1999 SEMINAR INFORMATION
"TECH ON TIME FOR '99"
INDEX
FORD & Chrysler

1999 SEMINAR INFORMATION

"TECH ON TIME FOR '99"

In this third manual on "TECH ON TIME FOR '99" seminar, we begin with FORD'S new 4R100. A look at the E4OD, AX4S/AX4N, AODE/4R70W and the 4R44E transmissions are just a portion of the information provided in this section of the seminar. Updates and part changes, problems and fixes for FORD transmissions fills this manual with valuable information. This manual concludes with information on Chrysler units including a look at the new 45RFE.

Figure 1

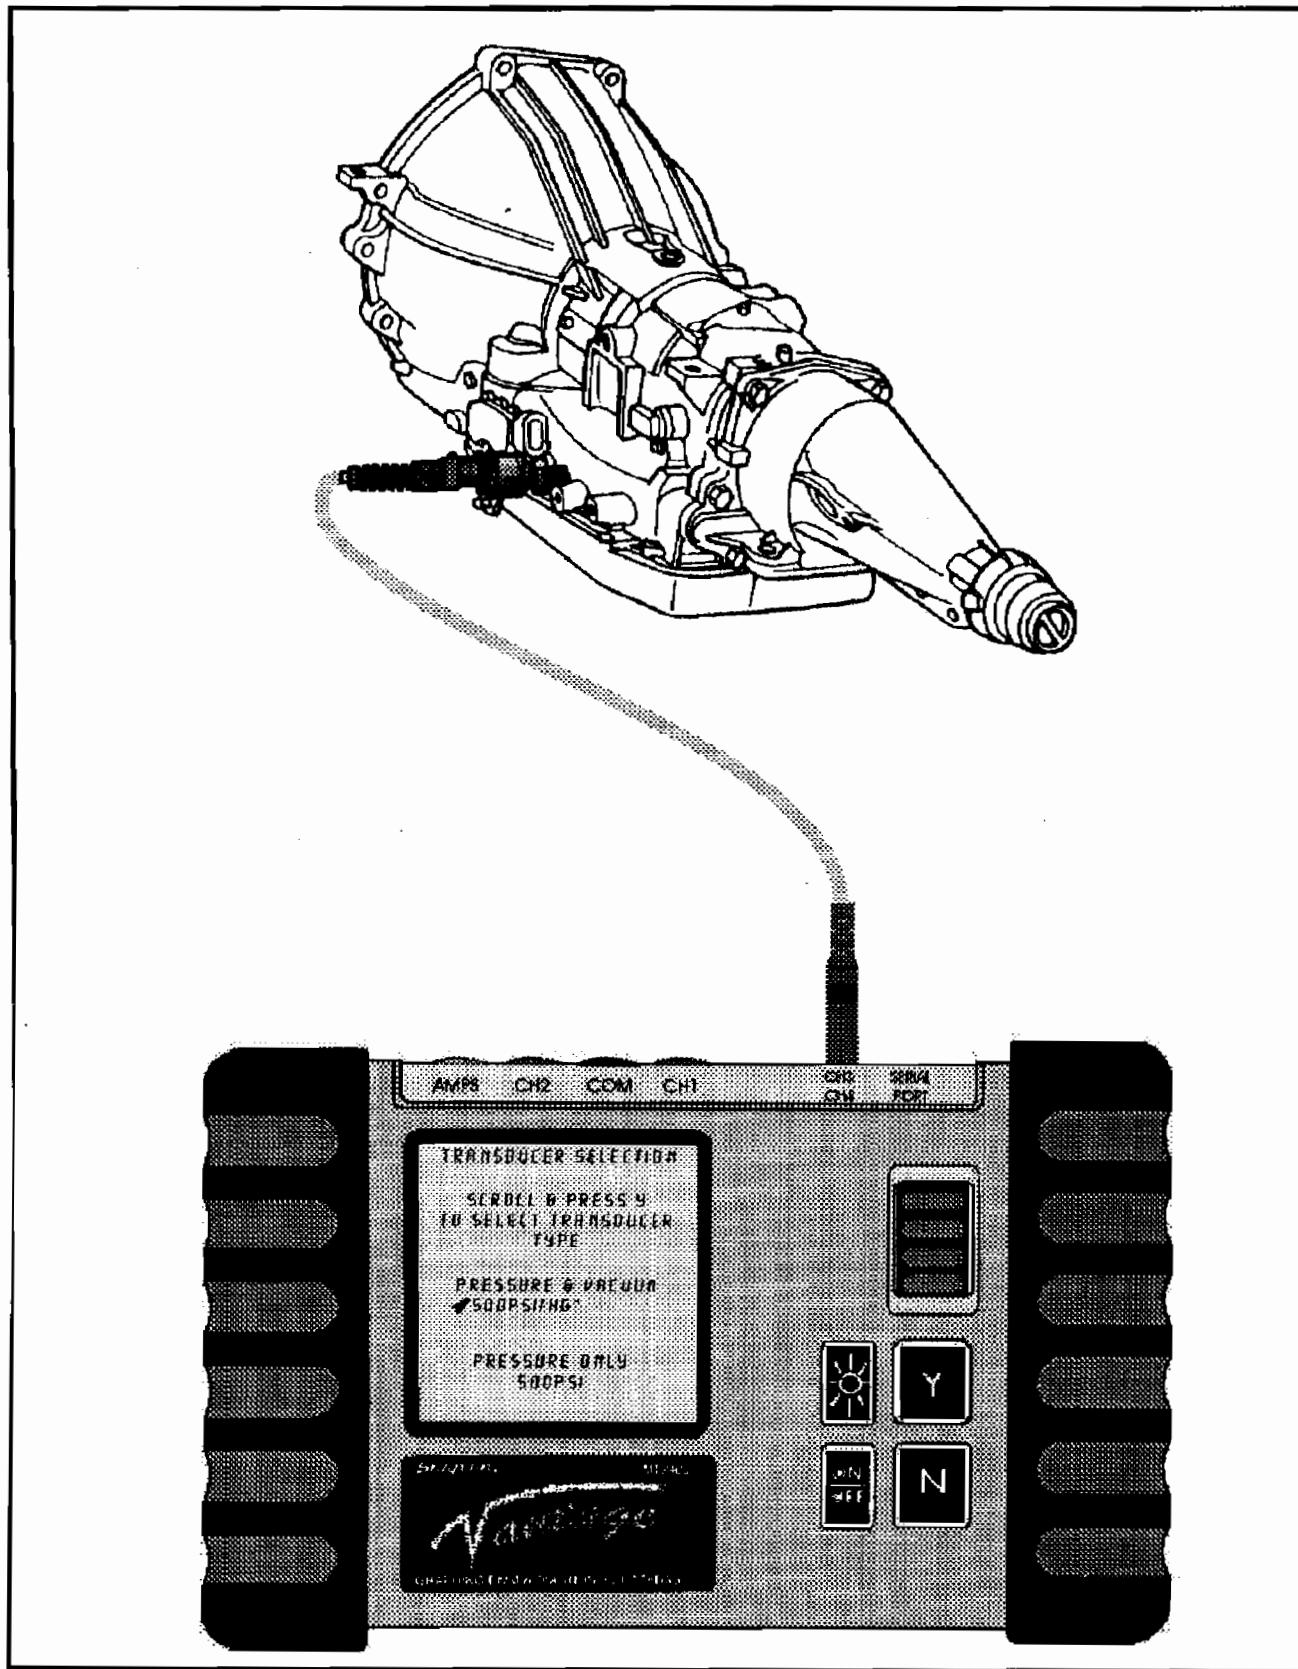
CORRECTION: Snap-on® Diagnostics has introduced pressure transducers that will screw into a pressure service port with the proper adapter and **ELECTRICALLY** connect to the Snap-on® Vantage® as shown in figure 1.

Figure 2

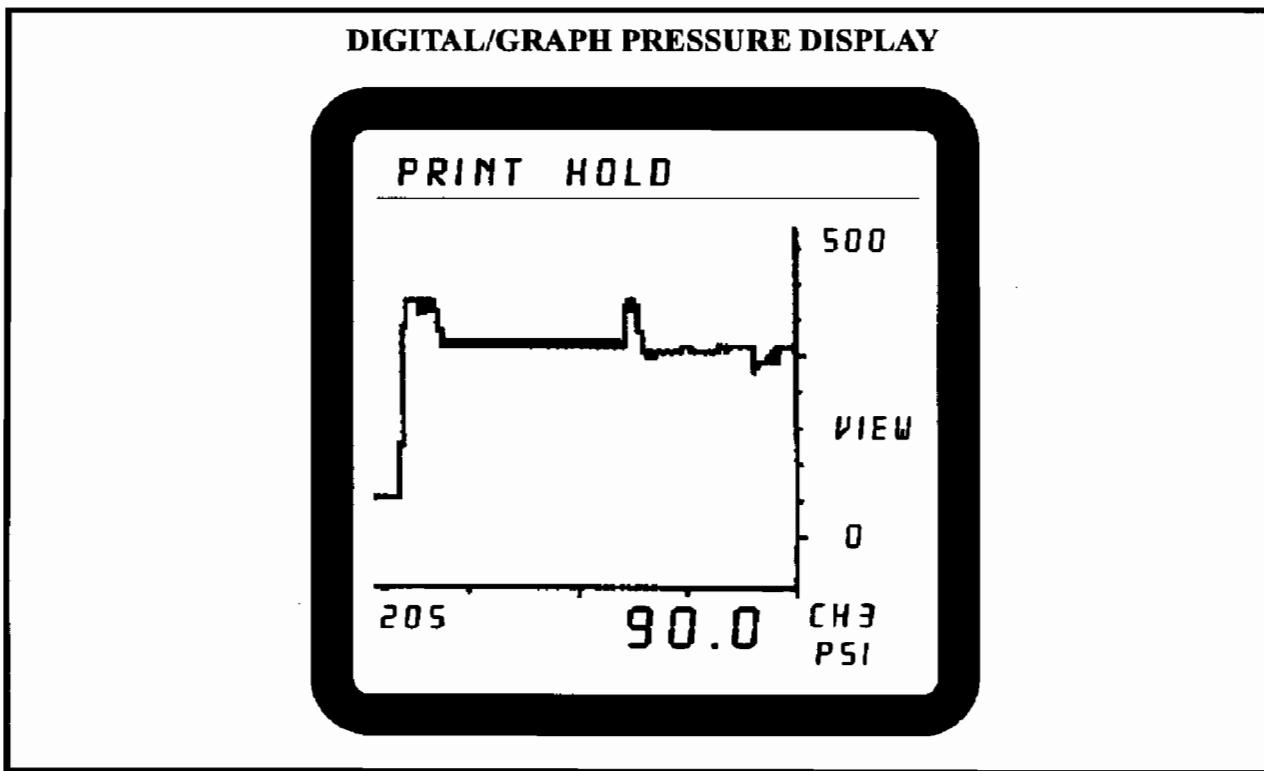
The actual PSI reading is now displayed on the Vantage® screen and can be viewed as a digital readout and as a graph as seen in figure 2.

Figure 3

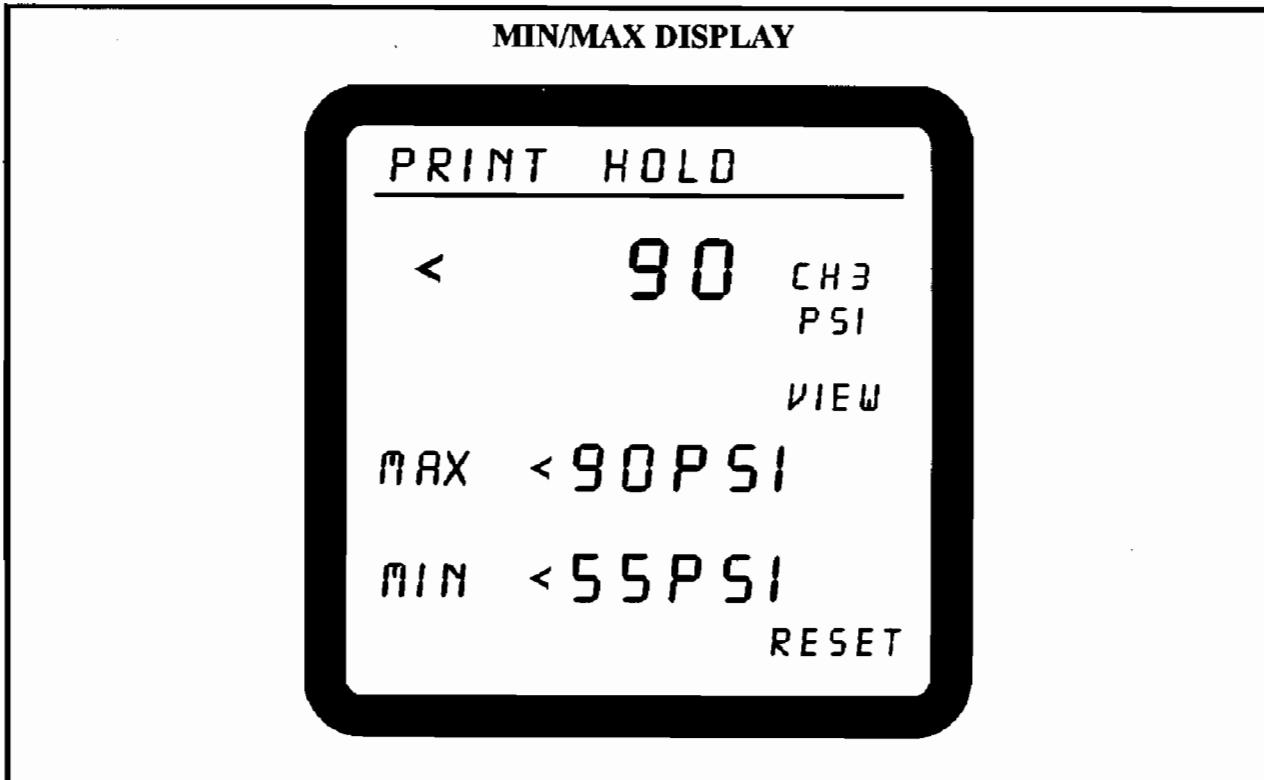
The Vantage® MIN/MAX feature can also be used at any time to record the highest and the lowest pressure seen in the event of a pressure spike as seen in figure 3.

Figure 4

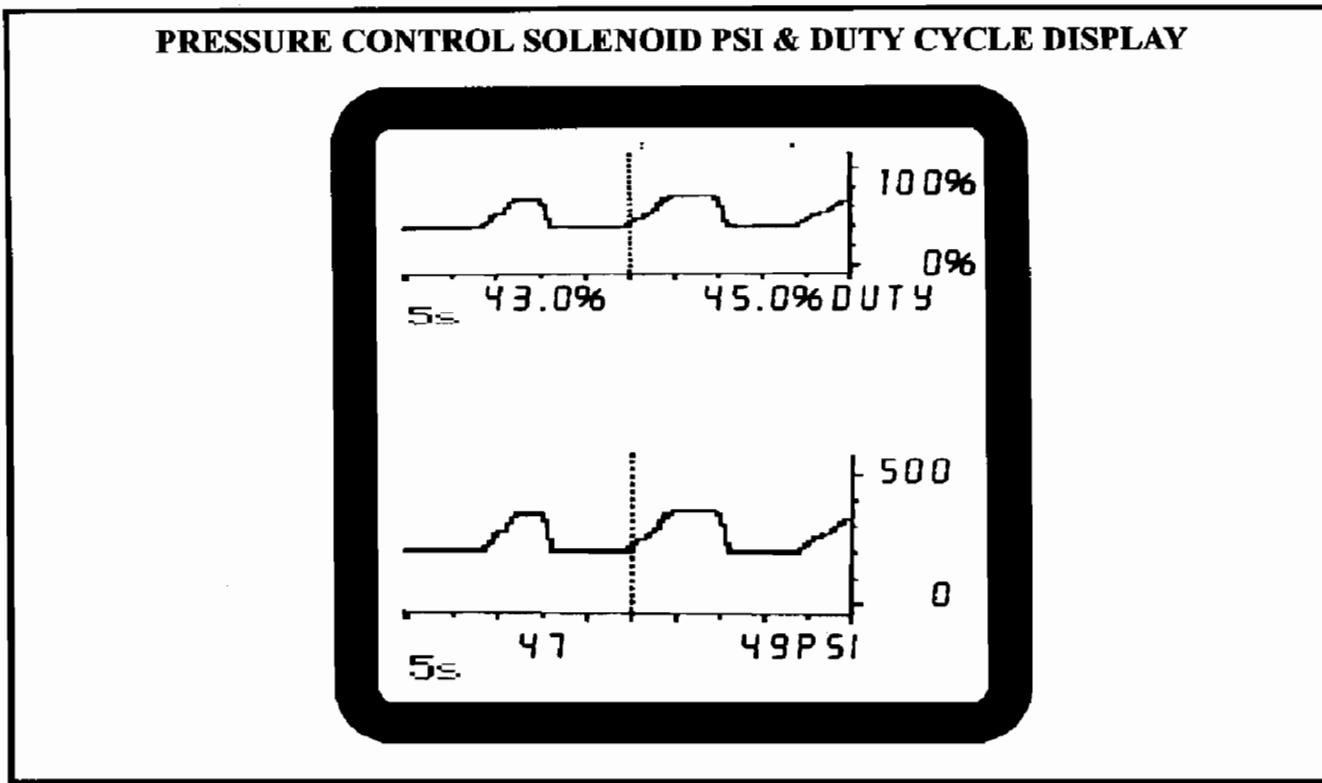
Illustrated in figure 4, the operation of the pressure control solenoid is displayed, as a slight snap of the throttle takes place, an instant change in the PSI reading and percentage of duty cycle as the throttle was snapped can be viewed on the same screen.

Figure 5

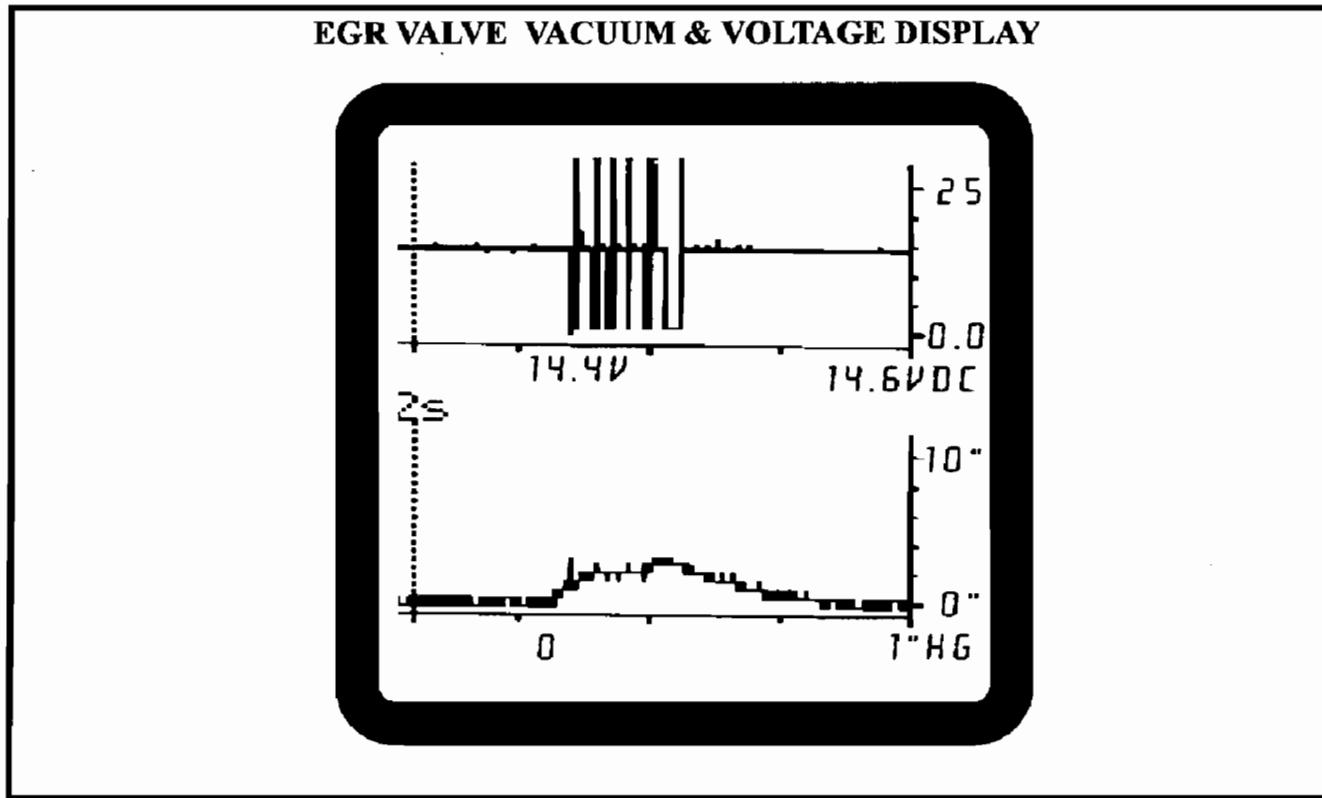
The transducers are also capable of reading vacuum and as with pressure it can also be viewed as a digital or graphed display or both on the same screen. The display in figure 5 has the Vantage® and transducer connected to a solenoid operated EGR valve. With the Vantage® configured for vacuum testing, the vacuum reading for the EGR valve is displayed in inches of mercury and the voltage operating the EGR valve solenoid can also be seen all on the same screen.

This can be very valuable when trying to diagnose a TCC shudder problem that is EGR valve induced which may be missed on the scan tool.

Figure 6

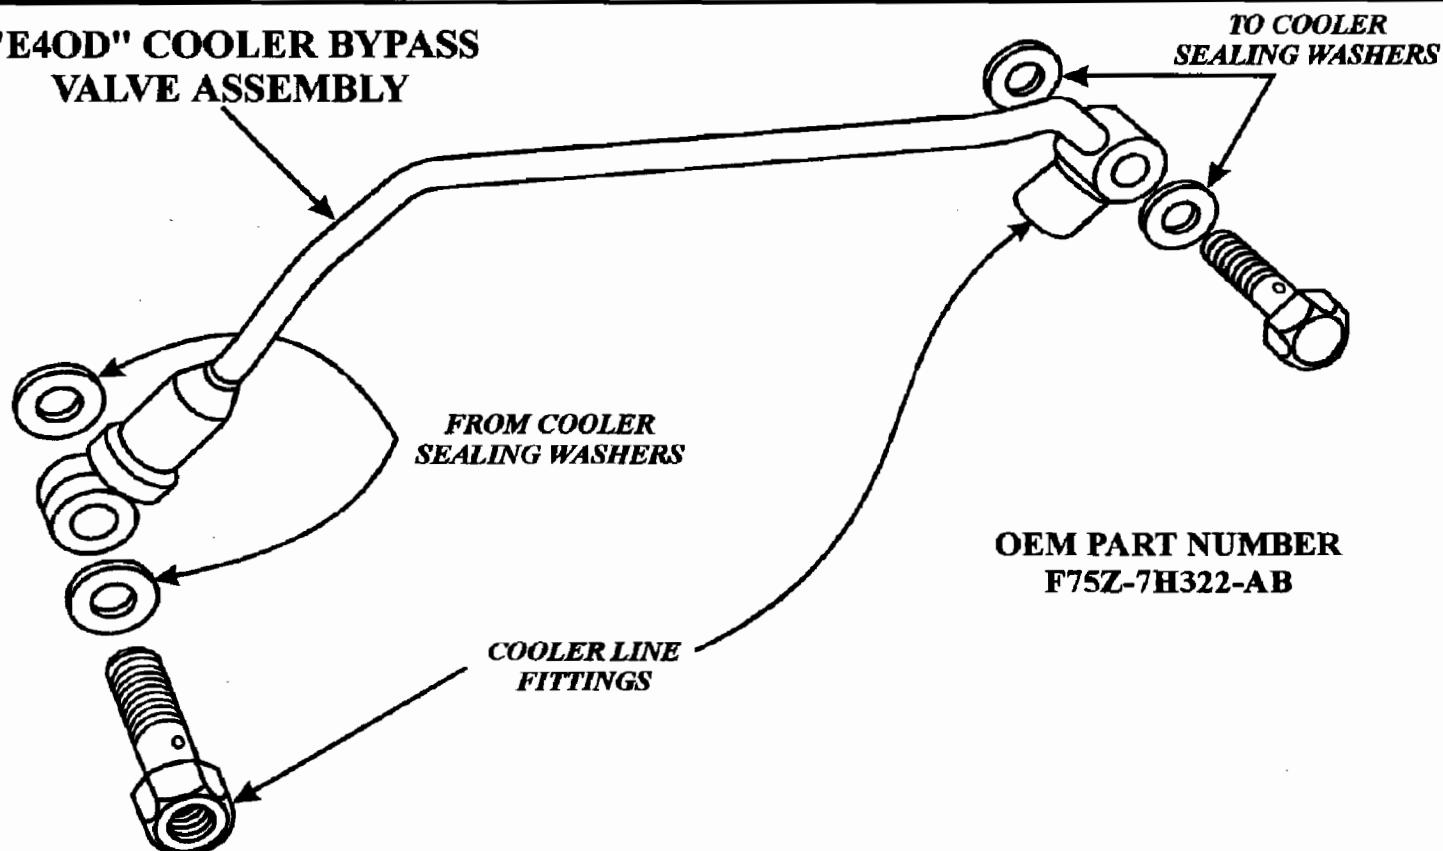
- (6) **MANUAL SHIFT LEVER** - There are two different external shift levers for this unit, one for Non-PTO transmissions and one for transmissions with the PTO option, as shown in Figure 6. We have provided you with the "Stamping" number as well as the OEM part number for both, as shown in Figure 6.

Figure 8

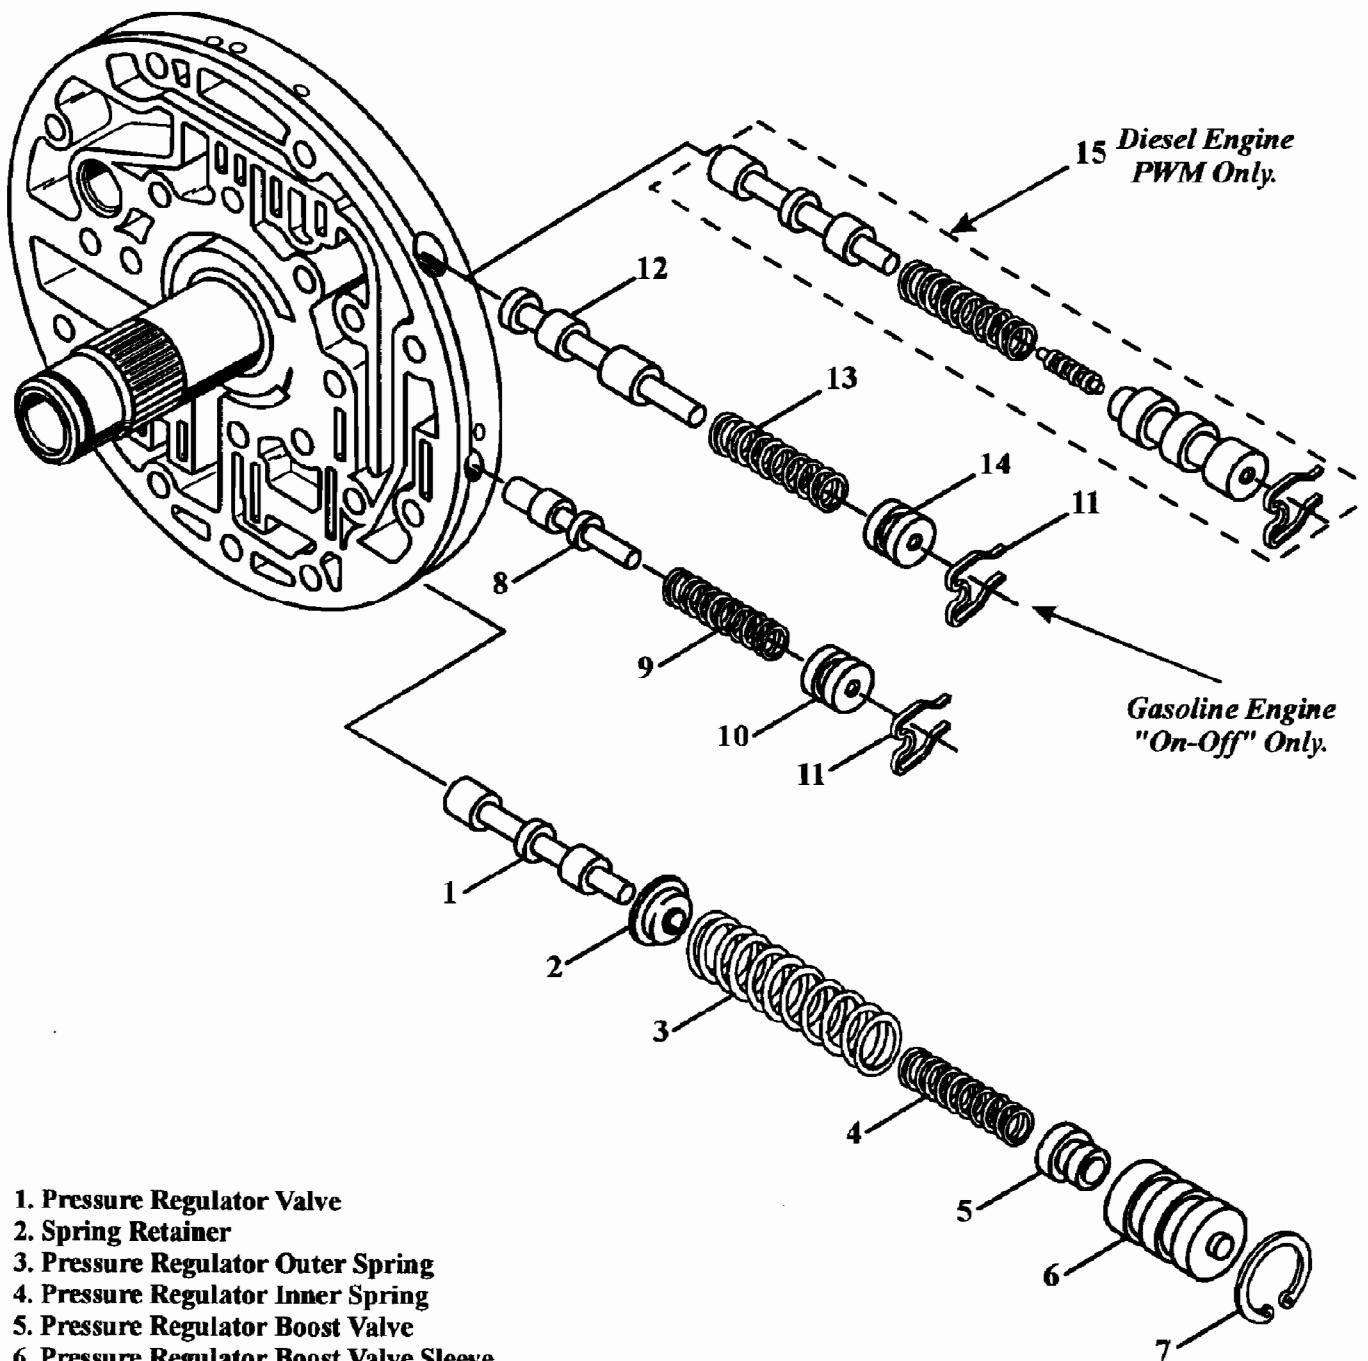
- (8) **TRANSMISSION COOLERS** - Most F-Series vehicles over 8500 GVW equipped with the 4R100 transmission have an external "Oil-To-Air" cooler **only**. Due to the internal design of the "Oil-To-Air" cooler, it cannot be adequately flushed to remove contaminants, and requires replacement during transmission rebuild. The only exception is that F-Series vehicles over 8500 GVW equipped with the 5.4L engine also uses a radiator "In-Tank" cooler in addition to the "Oil-To-Air" cooler. Refer to Figure 8 for transmission cooler information.
